TO: Honorable Chairman Hertz and Members of the Mount Kisco Planning Board

SUBJECT: NY Luxury Motors of Mount Kisco, INC.  
299 Kisco Avenue, Property ID #69.49-2-1

FROM: Jan K. Johannessen, AICP   
Village Planner

RE: Site Plan (Formal) & Wetland Permit  
NY Luxury Motors  
299 Kisco Avenue  
Section 69.49, Block 2, Lot 1

Drawn: NC Approved: DV  
Scale: 1" = 20'  
Date: 04/17/2018  
Project No: 17173  
17173-LA001 LAY LAY.scx  
Drawing No: **C-100**

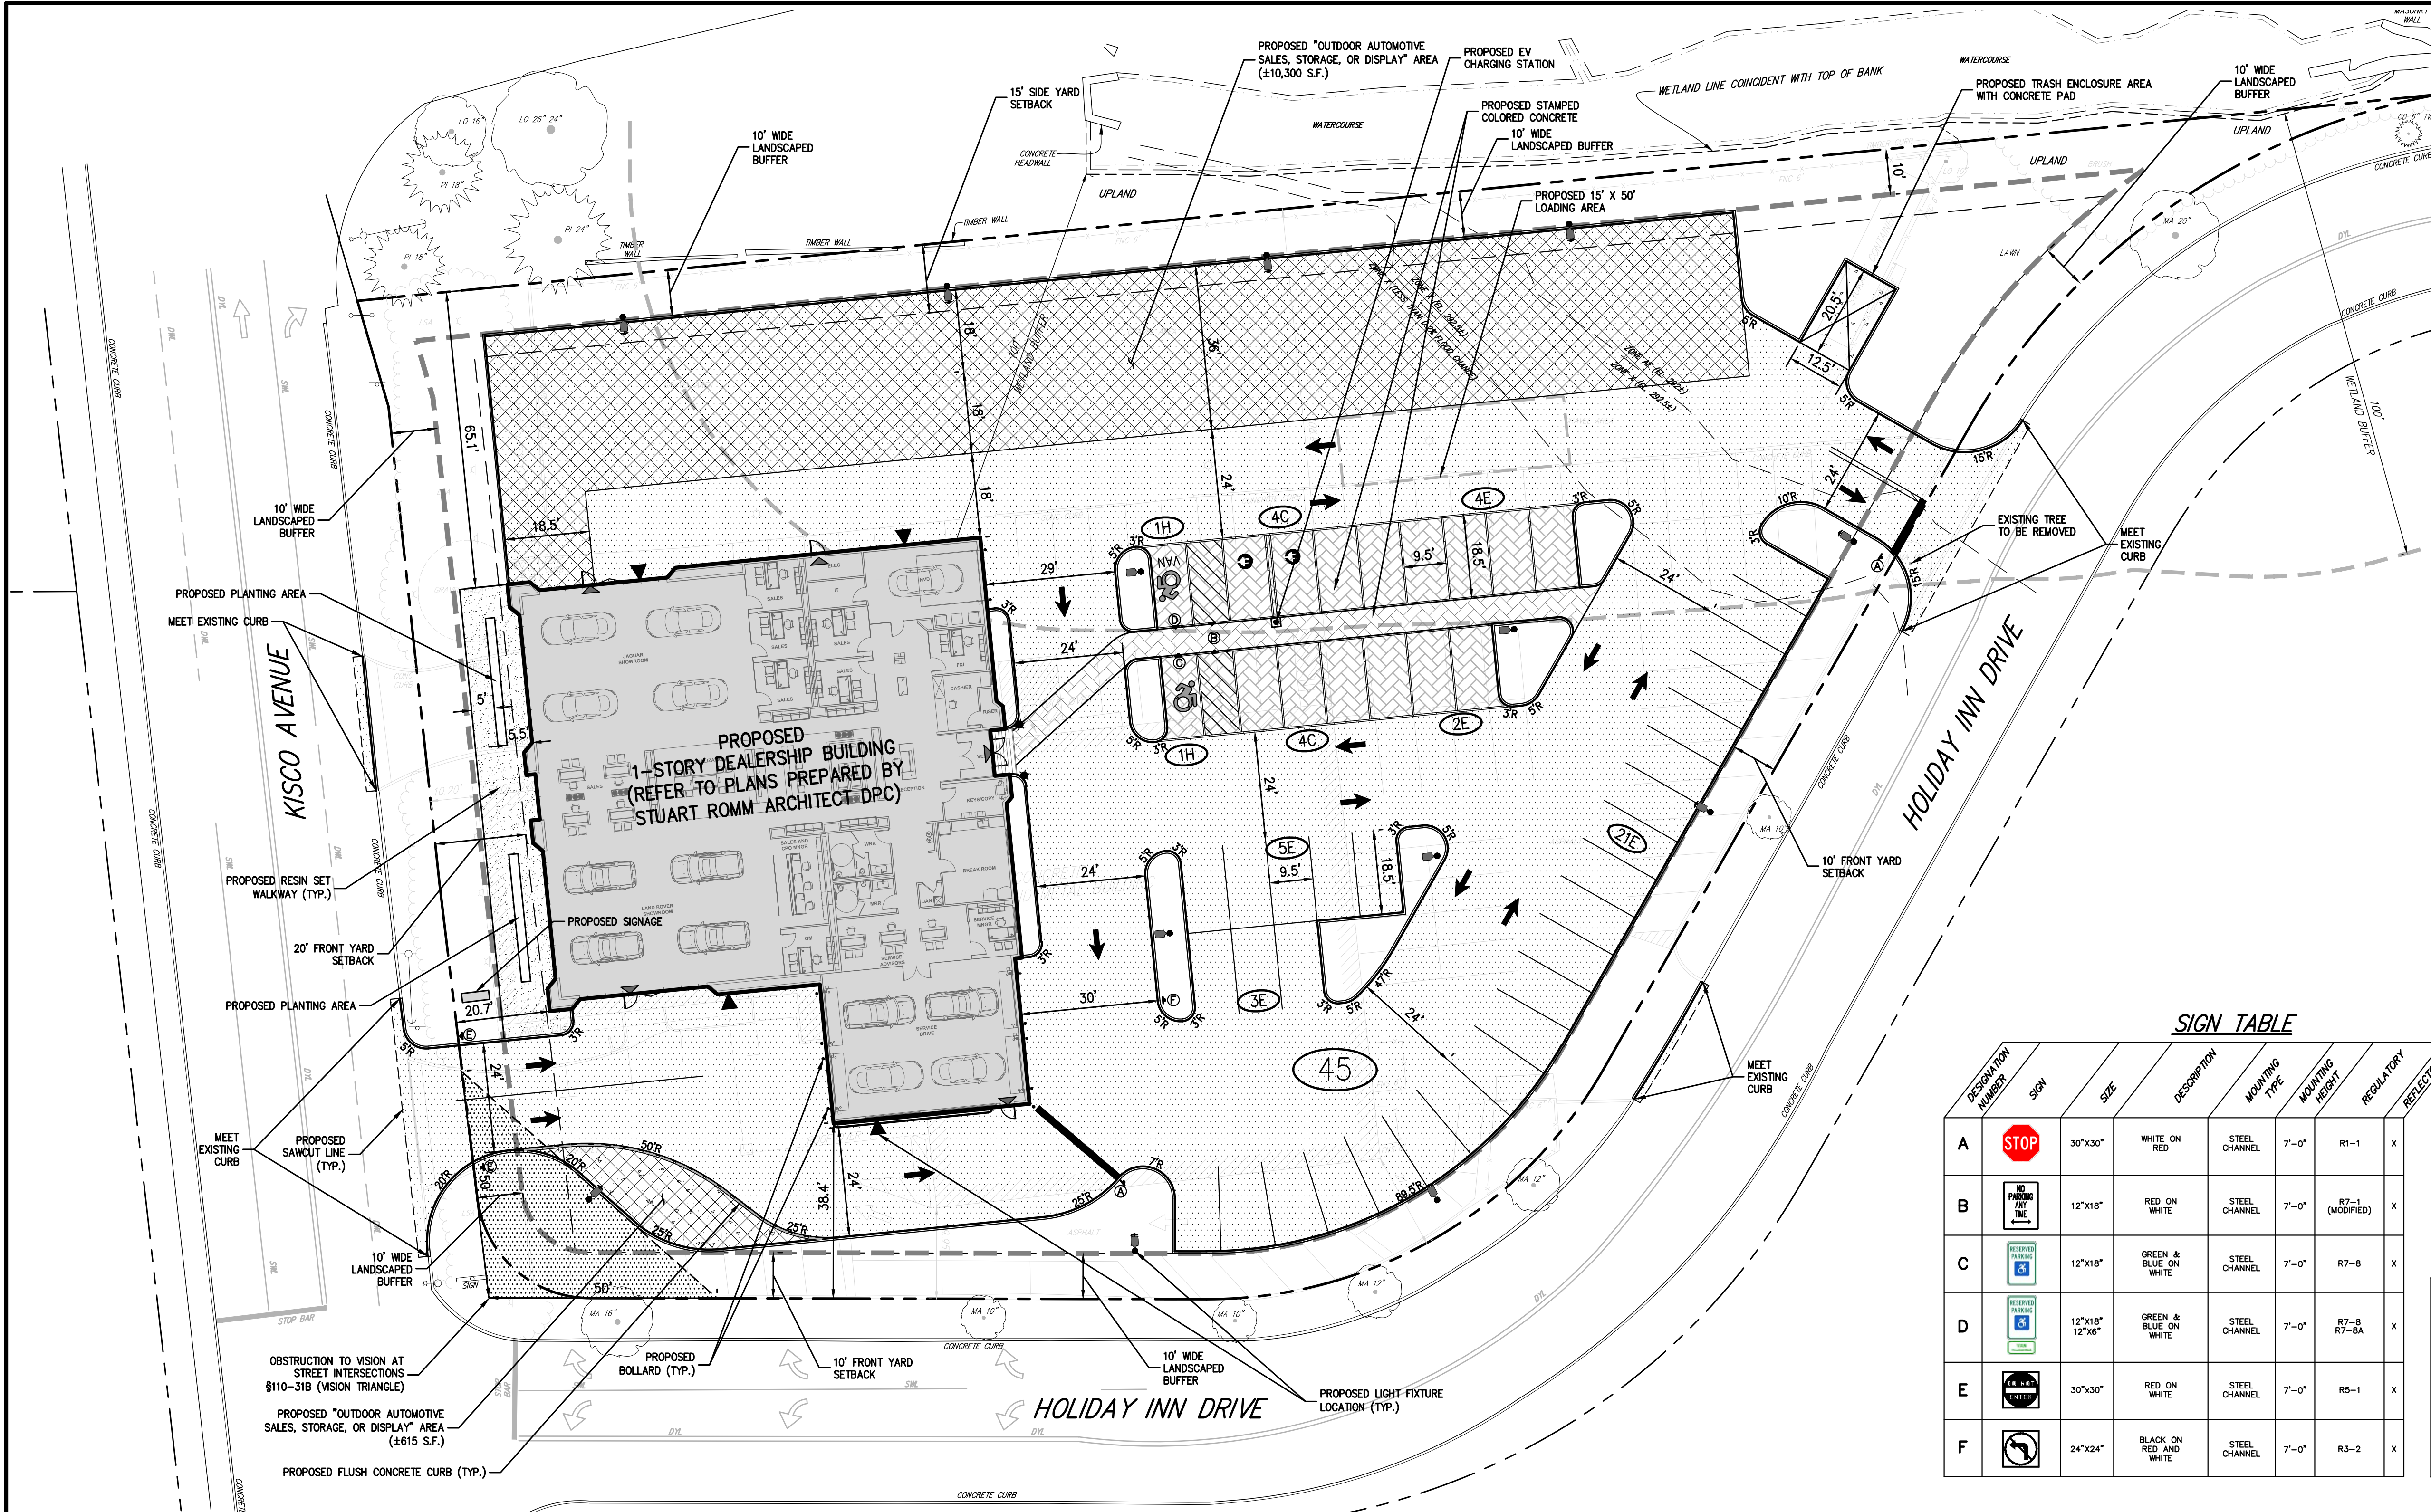
- (3). Maximum development coverage is 75%, proposed is 76.7% therefore; a maximum development coverage variance of 1.7% is required.
- The proposed trash enclosure is located in the northeast corner along Holiday Inn Drive. Pursuant to Village/Town of Mount Kisco Code §110-30 D. Trash compactors, dumpsters, and other large trash containers and; Chapter 110. Zoning Article V. Supplementary Regulations § 110-31. Supplementary development regulations.

- The proposed building is located within the 100 ft. wetland buffer. The lot, specifically the parking area located northeast is in the AE Flood Zone therefore; A Flood Development Permit and Elevation Certificate is required.
- The architectural plans A201a indicated a service department shop and support. Space counts are different than what is proposed on the site plan.
- Compliance to the extent regulated by Village/Town of Mount Kisco Code Chapter 66 Flood Damage Prevention is required.
- The property falls within the Village/Town of Mount Kisco's Designated Main Street Area.

- b. The applicant has noted the need for a variance relating to the dumpster enclosure; however, the need for the variance is not clear.
2. The applicant should provide, in writing, additional information pertaining to the existing and future use and occupancy of 41 Kensico Drive. While the parcel is no longer part of the instant application, the property is owned by the applicant and continues to be used for vehicle storage, which is not permitted as a stand-alone use. Maintenance of the property has also been an issue as of late.

8. The applicant is requesting a 1.7% development coverage variance. Given the change in scope and the fact that 45 parking spaces are being proposed, where 27 parking spaces are required, the applicant should make a concerted effort to modify the plan to be zoning compliant; this would require the applicant to convert just over 1,200 s.f. of development coverage into green space. As identified above, there appears to be flexibility and room to modify the plan to comply.
